September 16th, 2022

G-5514

Subject: **Addendum to -
Geotechnical Engineering Investigation & Soil Infiltration Evaluation
Proposed Short-Plat
4833 – 90th Ave SE
Mercer Island, Washington**

Sheet No. C-6.0 OF C-X.0

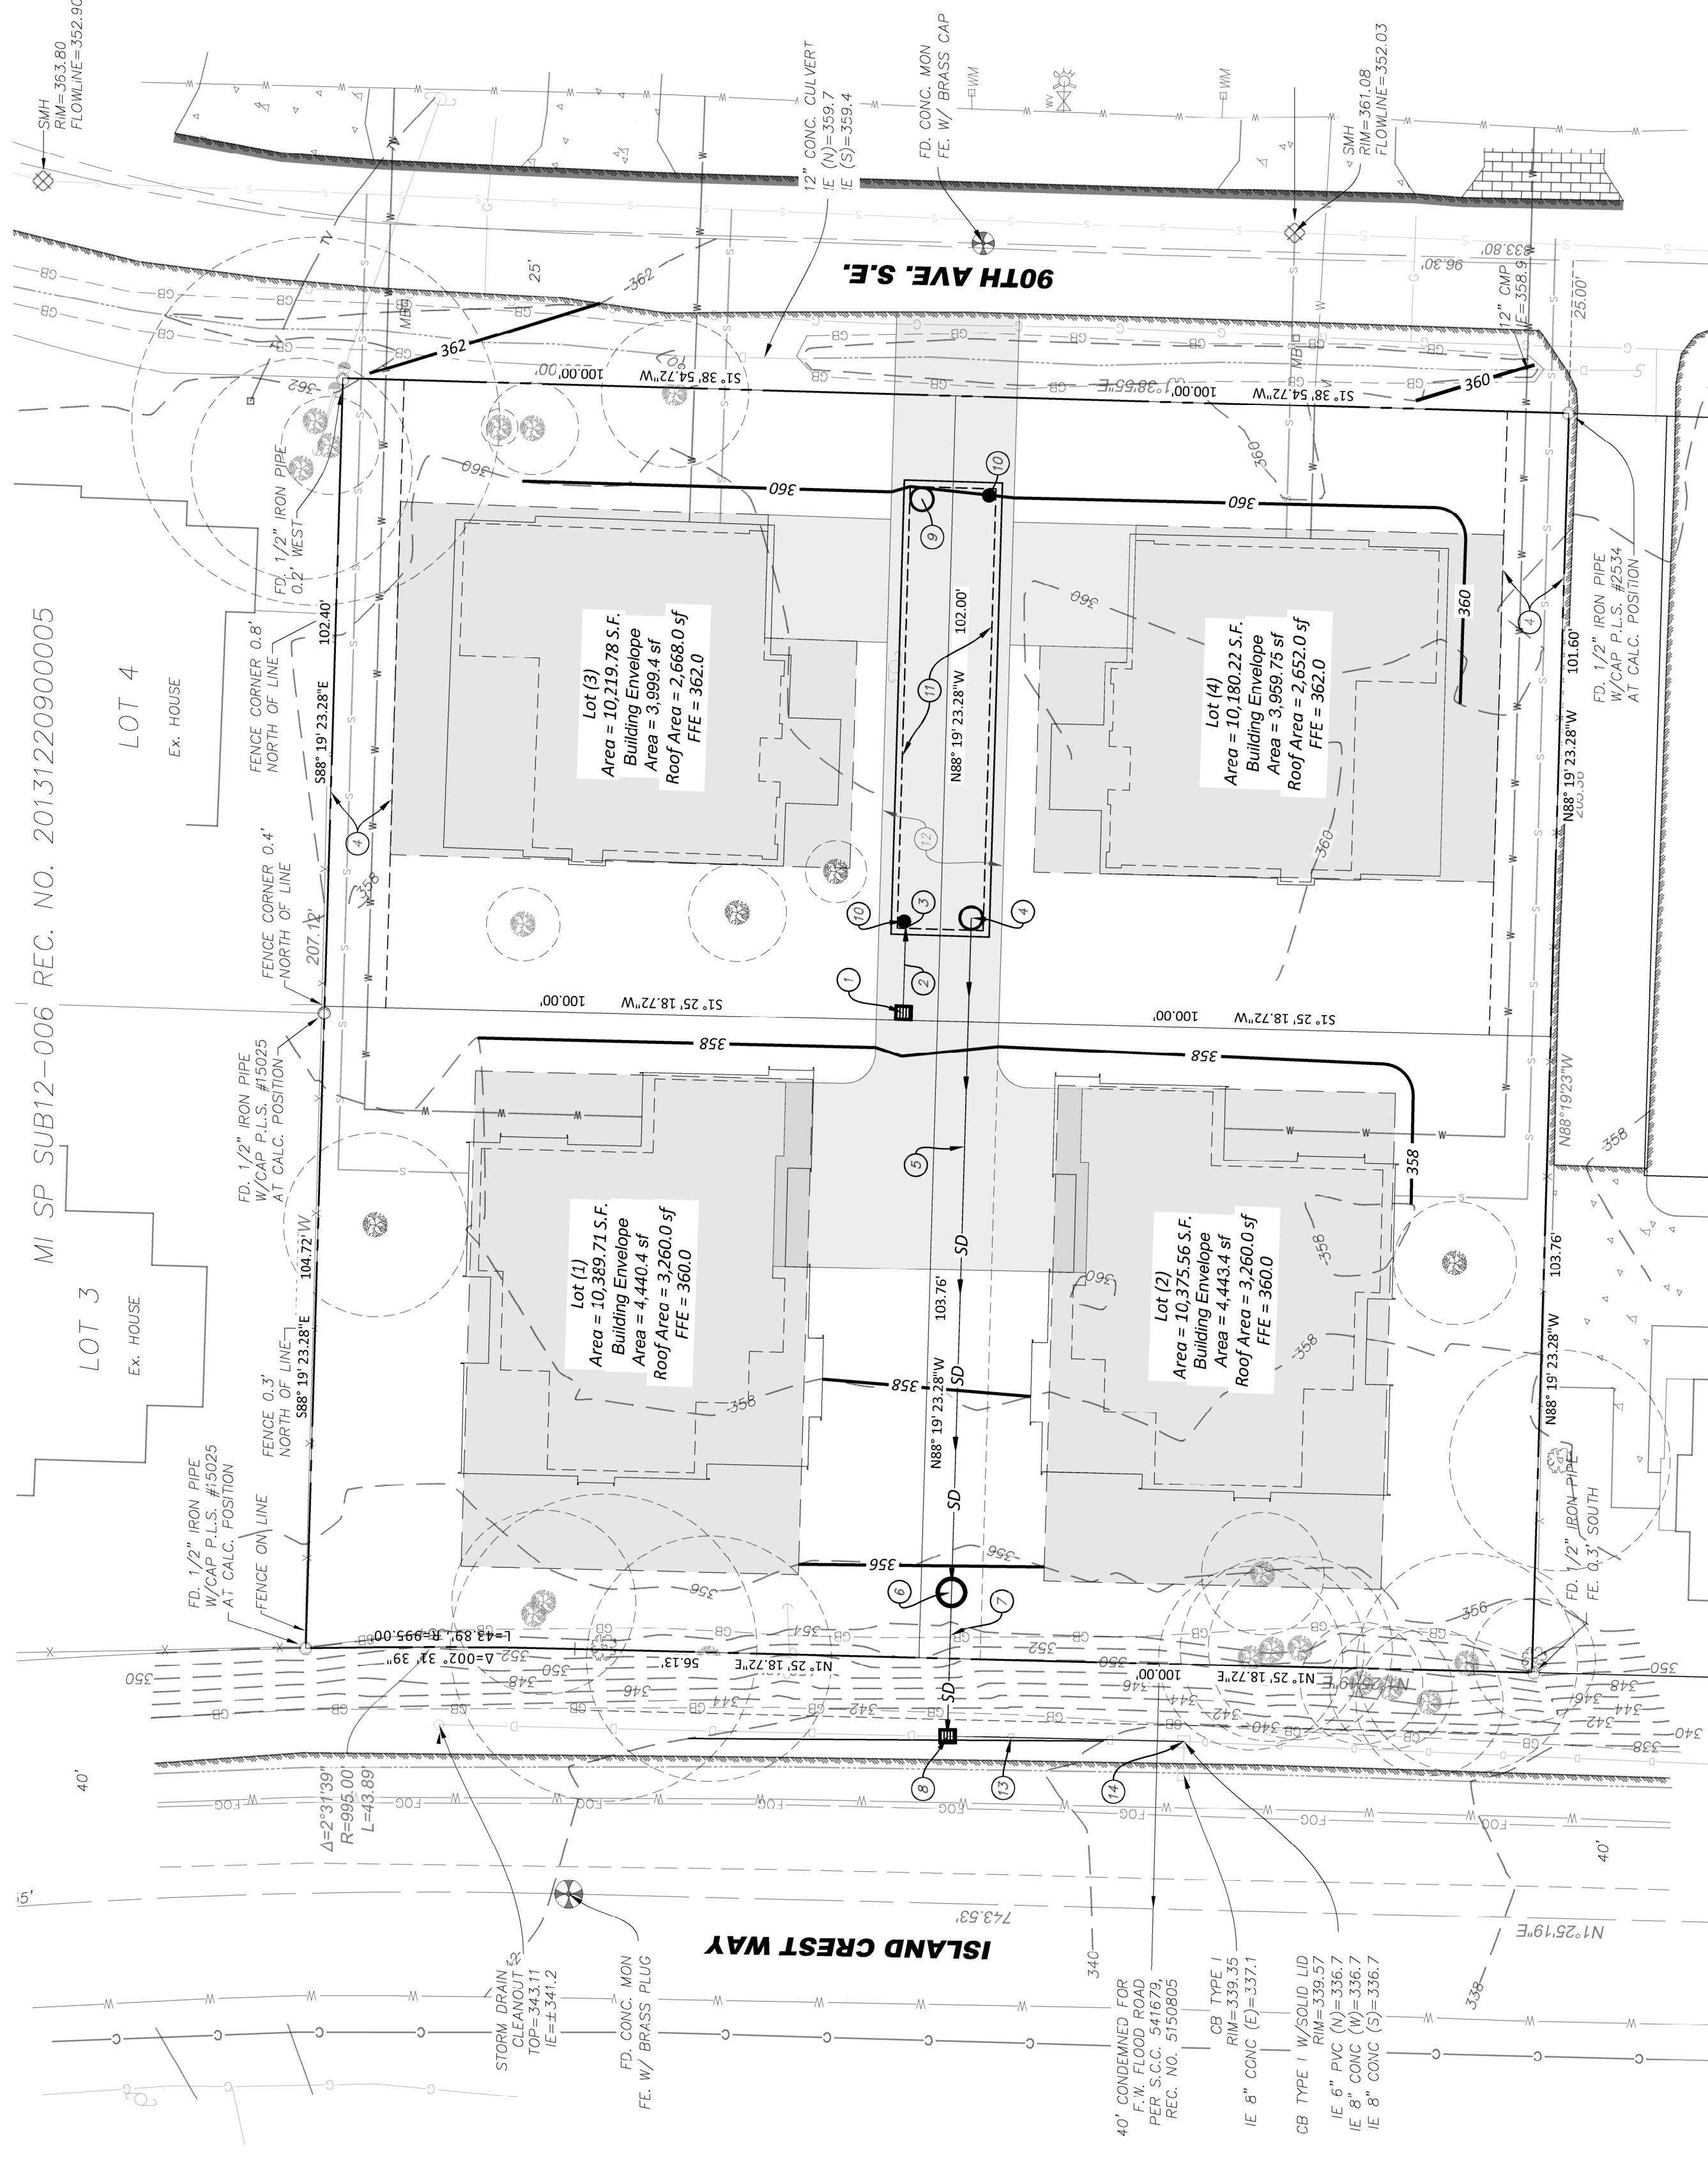
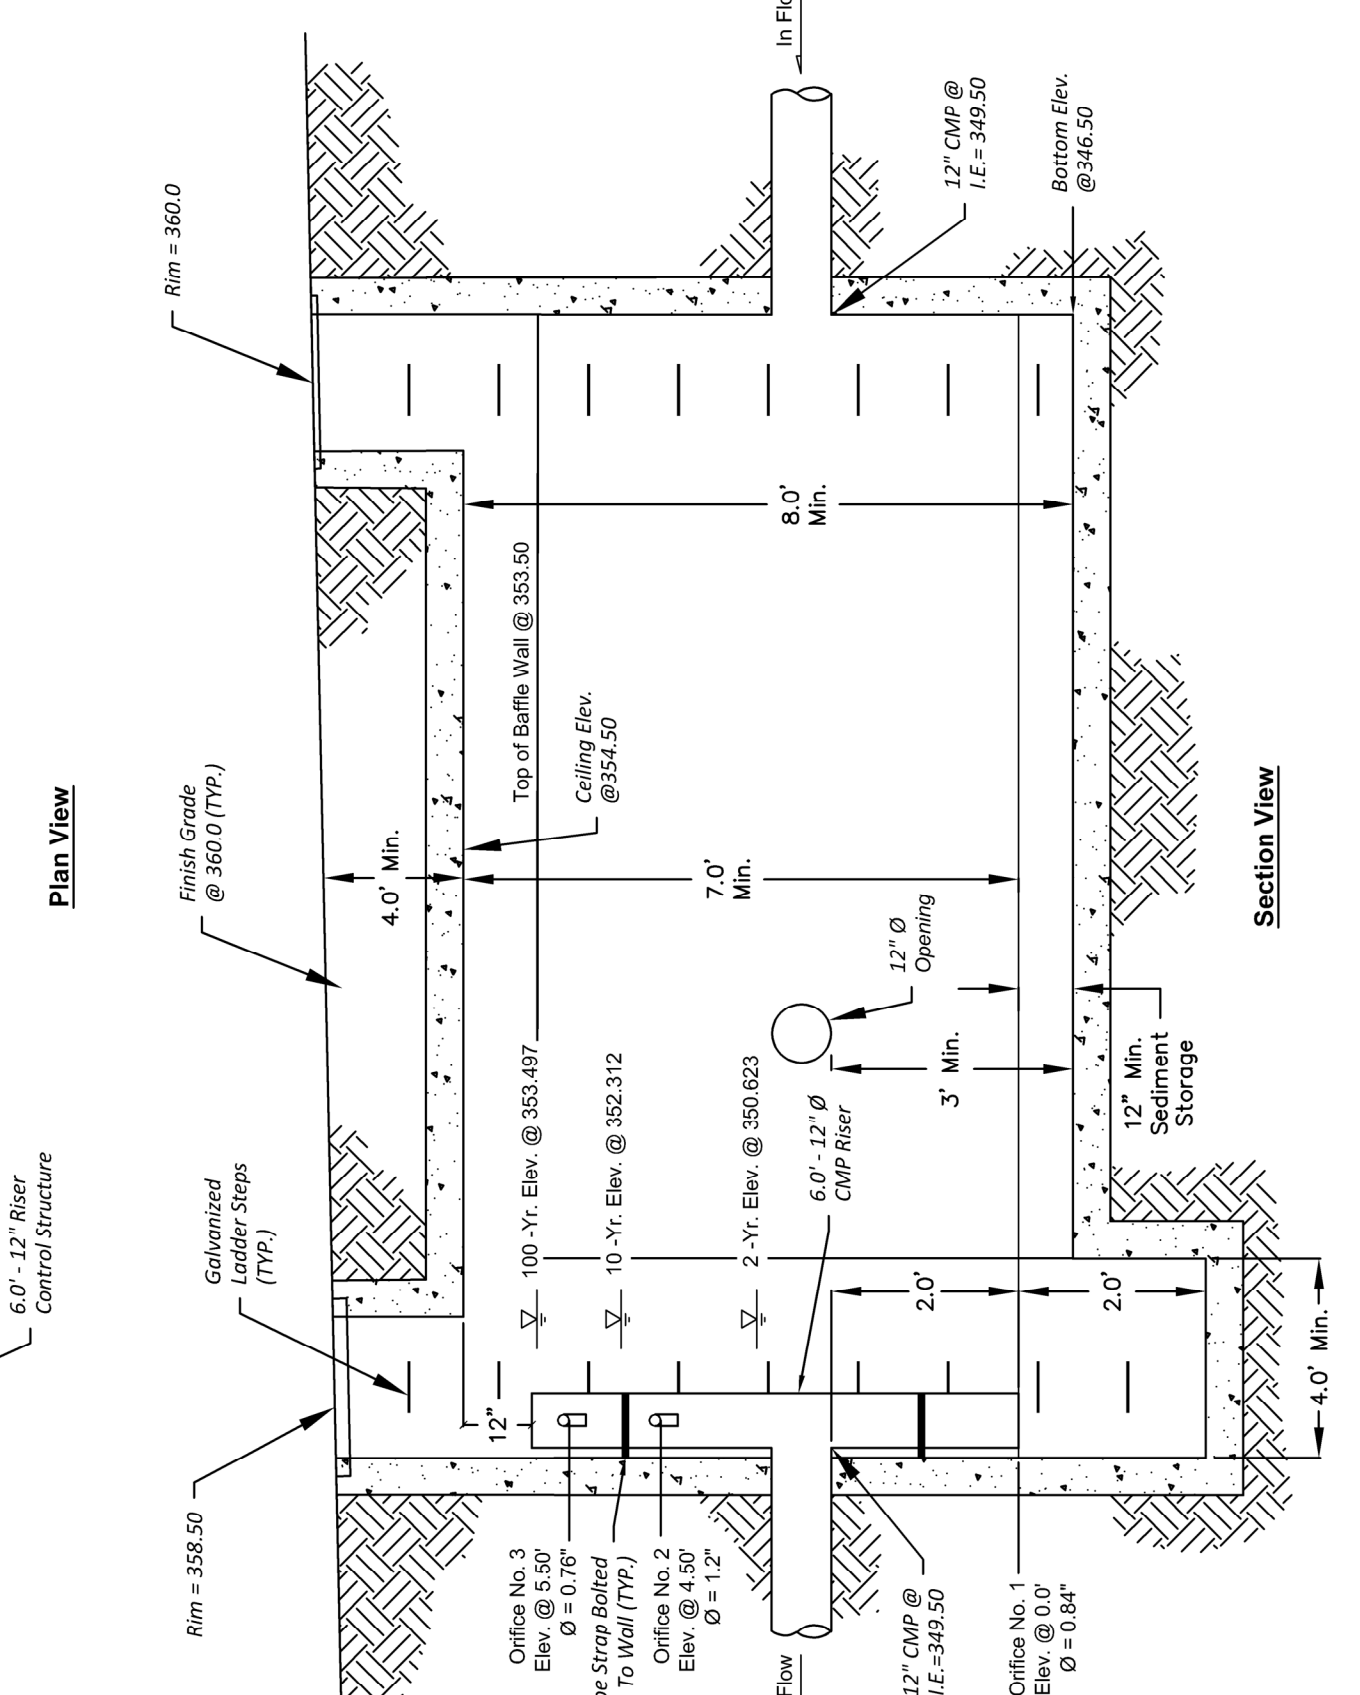
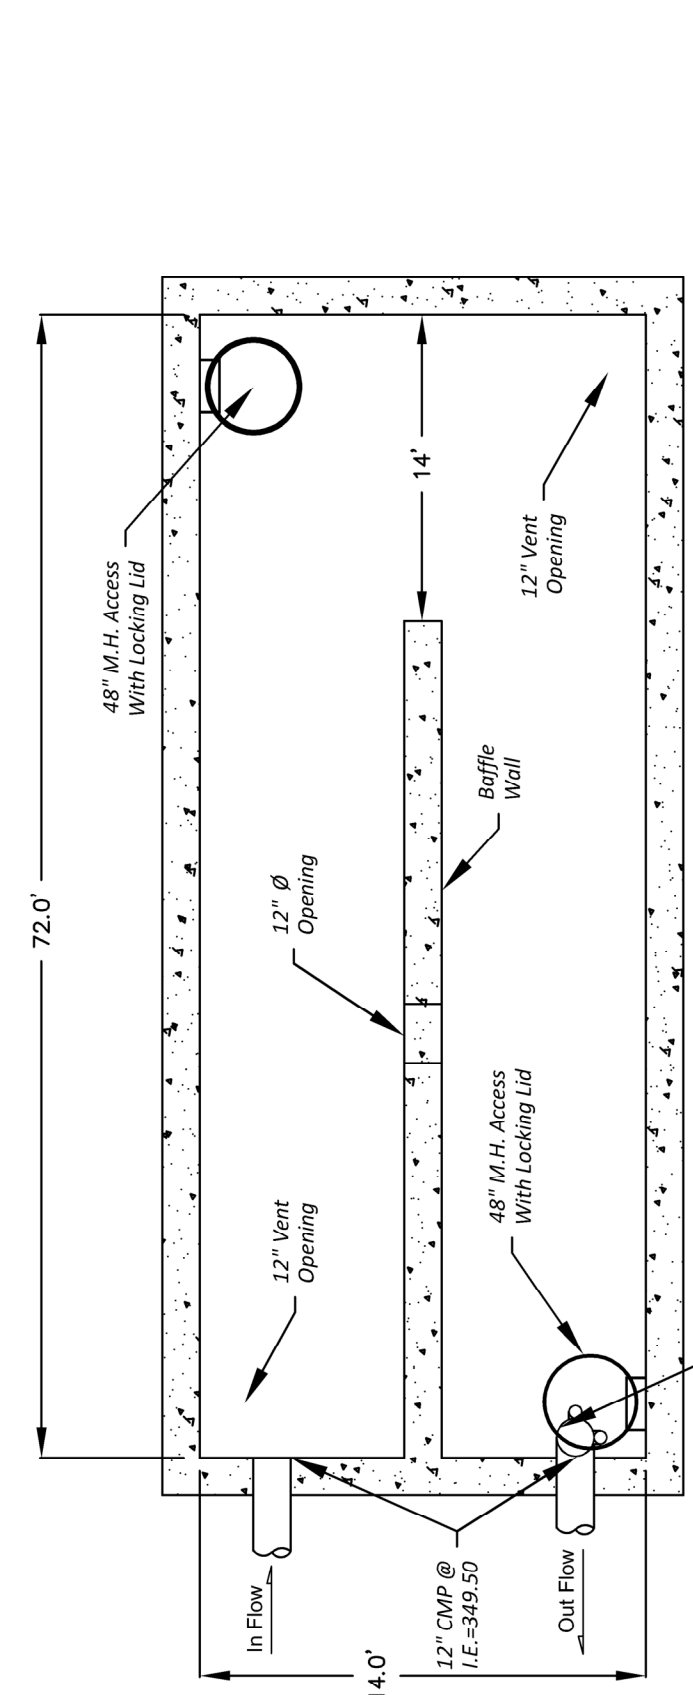
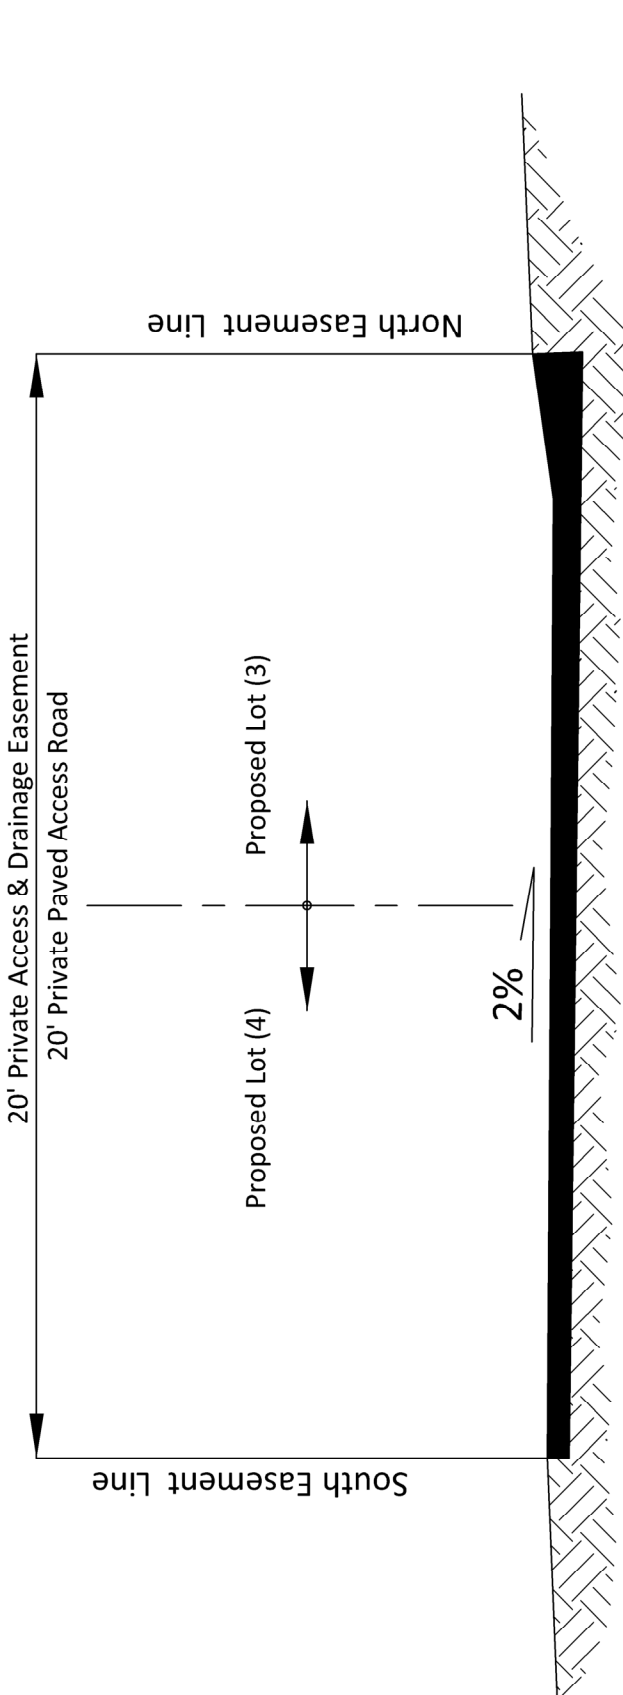
We reviewed the Preliminary Grading and Utilities Plan for the project. The plan was prepared by Pacific Land Engineering, LLC and is attached to this letter. Based on our review, we understand that a stormwater detention vault is proposed in the central-east portion of the property. The stormwater vault as proposed will discharge westerly to the City stormwater utility along the Island Crest Way east right-of-way. Construction of the stormwater facility will require excavations within the steep slope area at the west side of the site and adjacent City right-of-way. Our geotechnical recommendations regarding the construction of the proposed stormwater facility are provided in the following sections to this report.

Based on the proposed configuration we estimate that excavations necessary for the vault construction will reach depths of up to approximately 15 feet below grade. Temporary excavations into the very dense, glacial till soils for construction of the stormwater vault and

storm drain to the utility can be completed at near vertical inclinations as recommended in our geotechnical report. Approximately 1 to 2 feet of weathered soils at the surface may need to be sloped at 1H:1V, if present. During the installation of the stormwater vault, the excavation walls should be draped with plastic sheeting to protect workers from loose gravel, if present.

Excavation into the steep slope region at the west property line and adjacent right-of-way will be required to complete the stormwater tie-in to the City utility. Based on the results of our geotechnical investigation, the slope is underlain with cemented glacial till soils. In our opinion, excavation trenching into the slope for the stormwater tie-in can be completed at near vertical inclinations without destabilizing the slope. For worker protection, the excavated trenches should be shored with trench boxing or equivalent.
